**NOVEMBER 19, 2024**  
**PROJECT NO: 1909-5772**  
**SENT VIA: EMAIL**  
**JOSIANE.GERVAIS@OTTAWA.CA**

**RE: TRANSPORTATION IMPACT ASSESSMENT UPDATE LETTER**  
**6160 THUNDER ROAD AND 5348 BOUNDARY ROAD**  
**CITY OF OTTAWA**

This update letter was originally submitted in August 2024. Following receipt of agency comments dated October 25, 2024, from Josiane Gervais via Stephan Kukkonen, this update letter was updated to address the transportation related comment from the City, which is outlined below with Crozier's response:

Attachment D - Sight Line Drawings

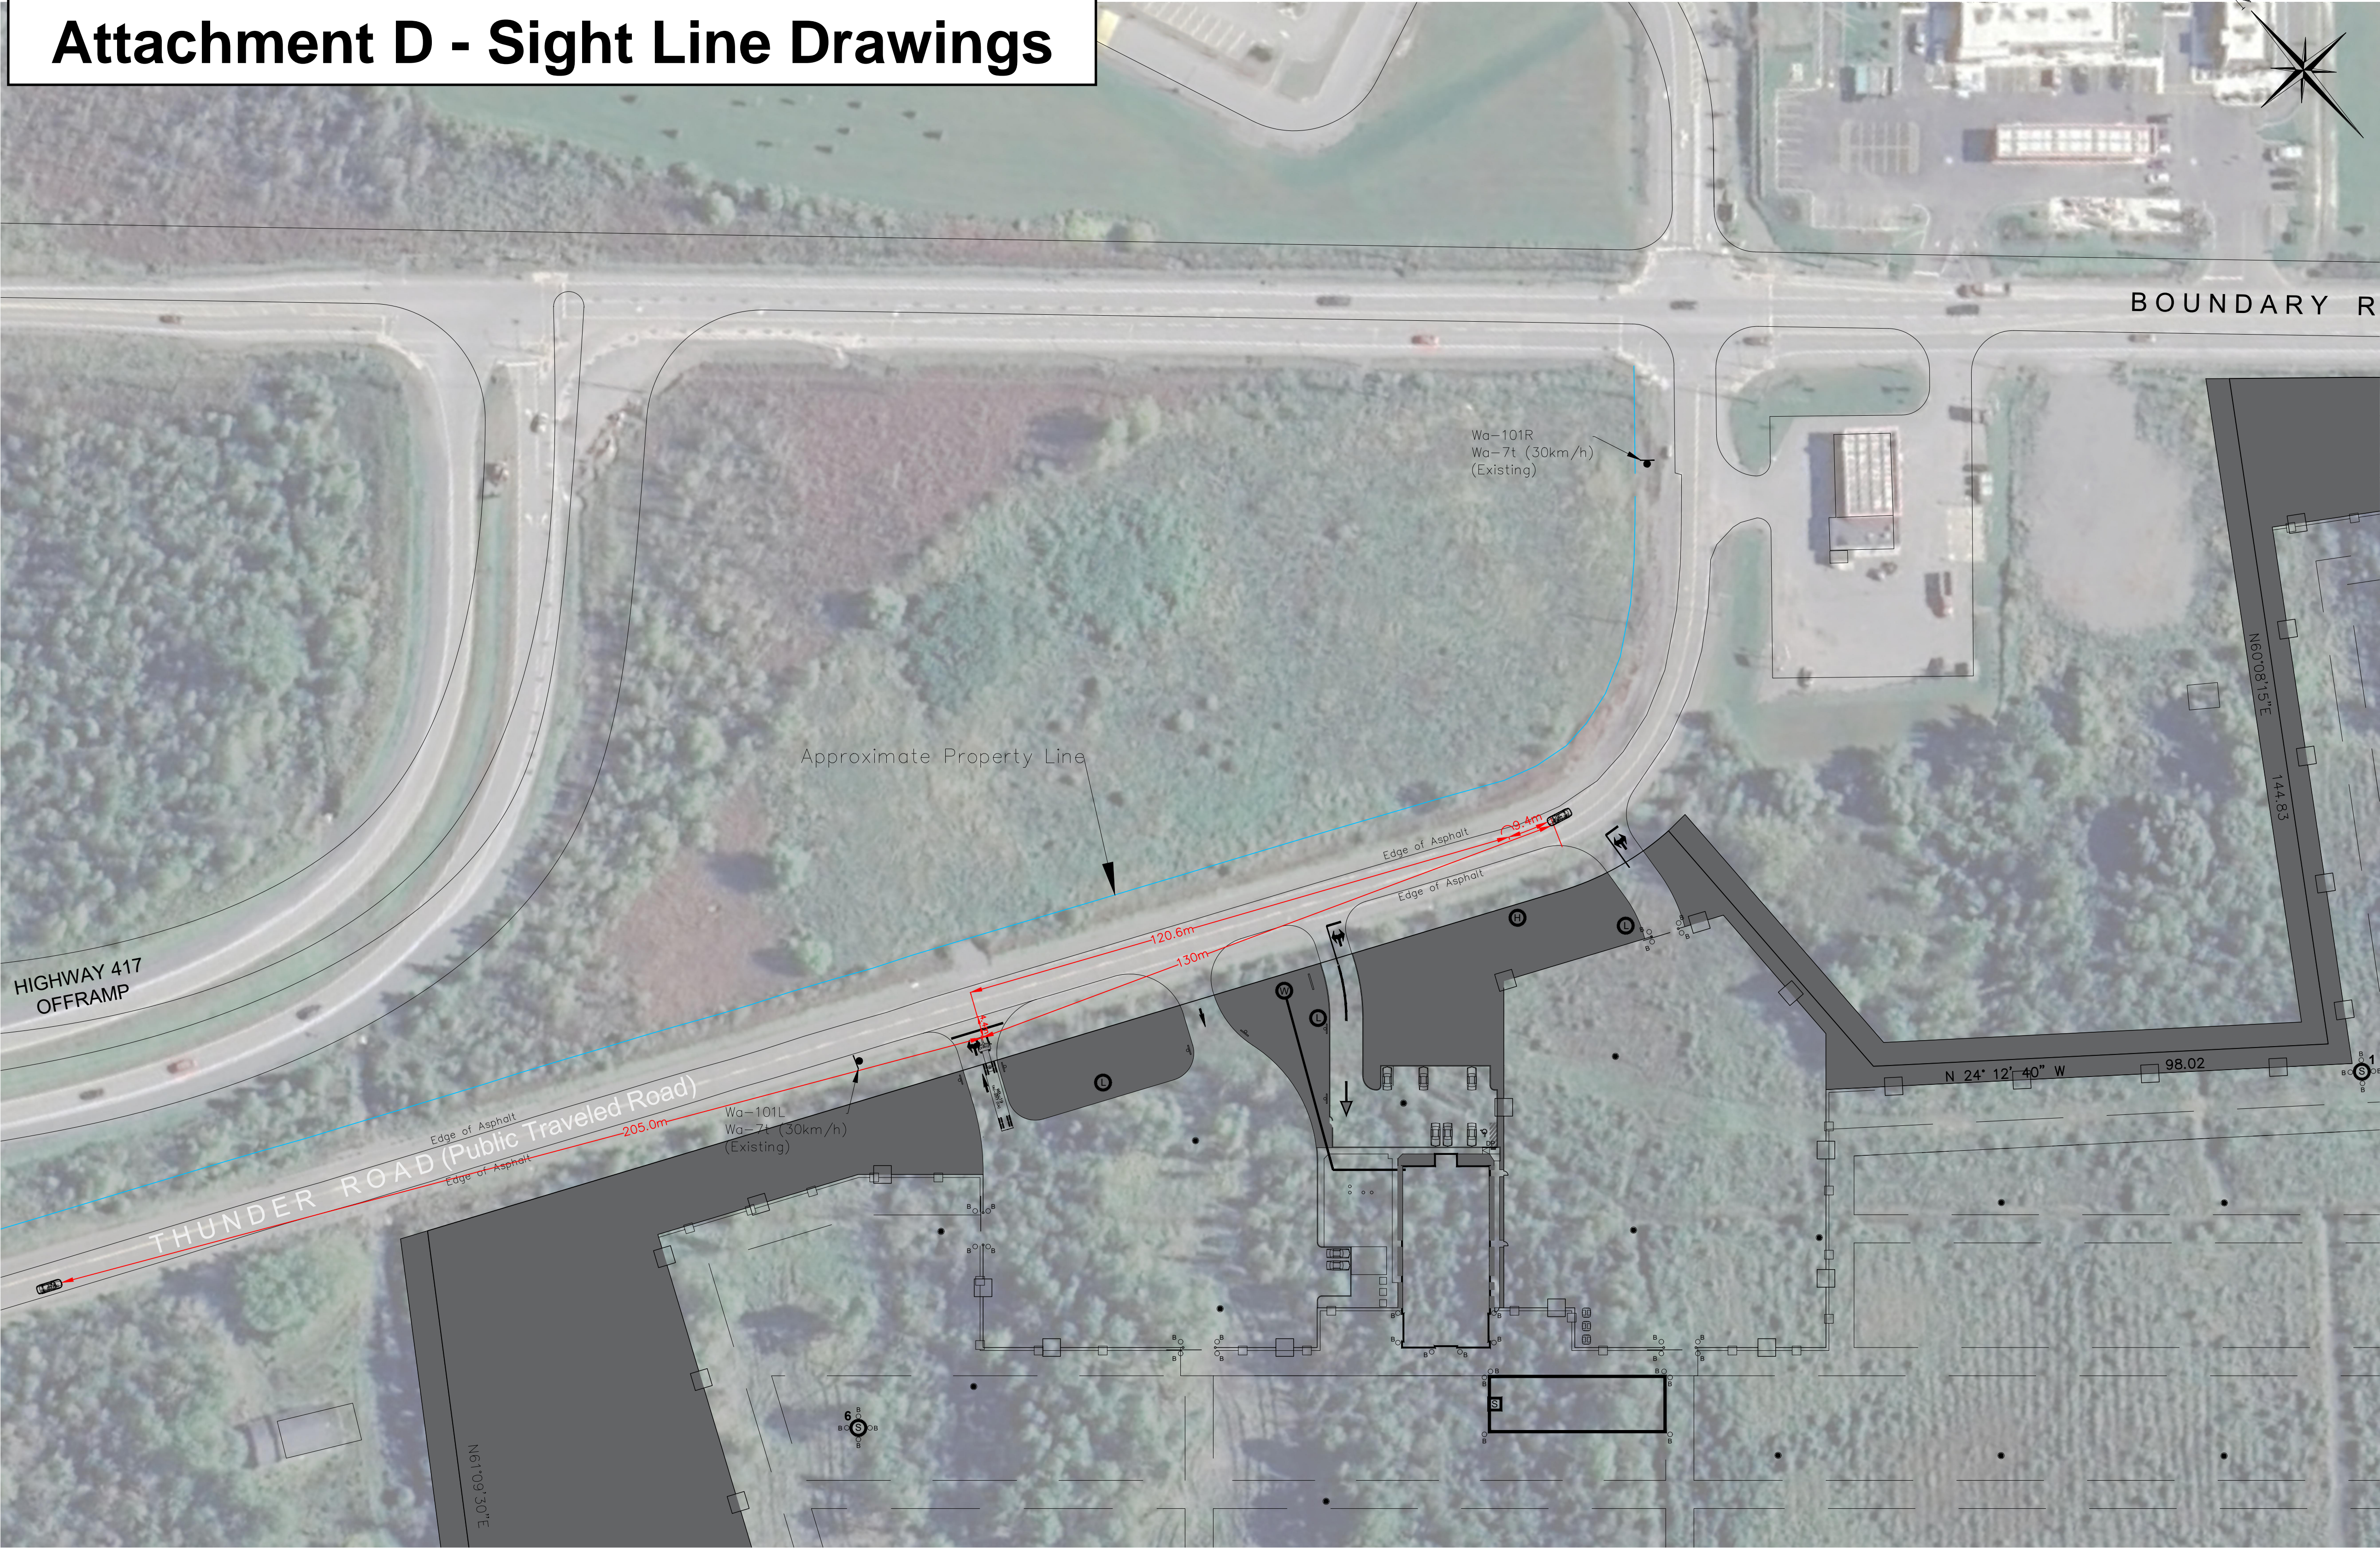
*Attachment D – Sightline sketches: The sightline analysis assumes that the property across the street will remain vacant and free of development and vegetation. Because a significant portion of the site across the street is utilized for the sight-lines analysis, staff have concerns that future development will impact these sightlines. Review sight-line analysis assuming a hypothetical development of the 6165 Thunder Rd property (i.e. show property lines and building setback lines as per zoning on the plan) and identify available sight distances under a future time horizon.*

- 2.3. Attachment D – Sightline sketches: The sightline analysis assumes that the property across the street will remain vacant and free of development and vegetation. Because a significant portion of the site across the street is utilized for the sight-lines analysis, staff have concerns that future development will impact these sightlines. Review sight-line analysis assuming a hypothetical development of the 6165 Thunder Rd property (i.e. show property lines and building setback lines as per zoning on the plan) and identify available sight distances under a future time horizon.

Please also note the 30km/hr warning signage for the curve on Thunder Rd on the plan for context and in support of the reduced speeds assumed for the sightline analysis. The revised plans can be submitted with the application.

**Crozier Response:** Crozier coordinated with the City and prepared updated sight line figures presented in **Attachment D**.

**Attachment D** contains updated sketches of the sight lines to demonstrate the visibility requirements and available visibility from the proposed site accesses.
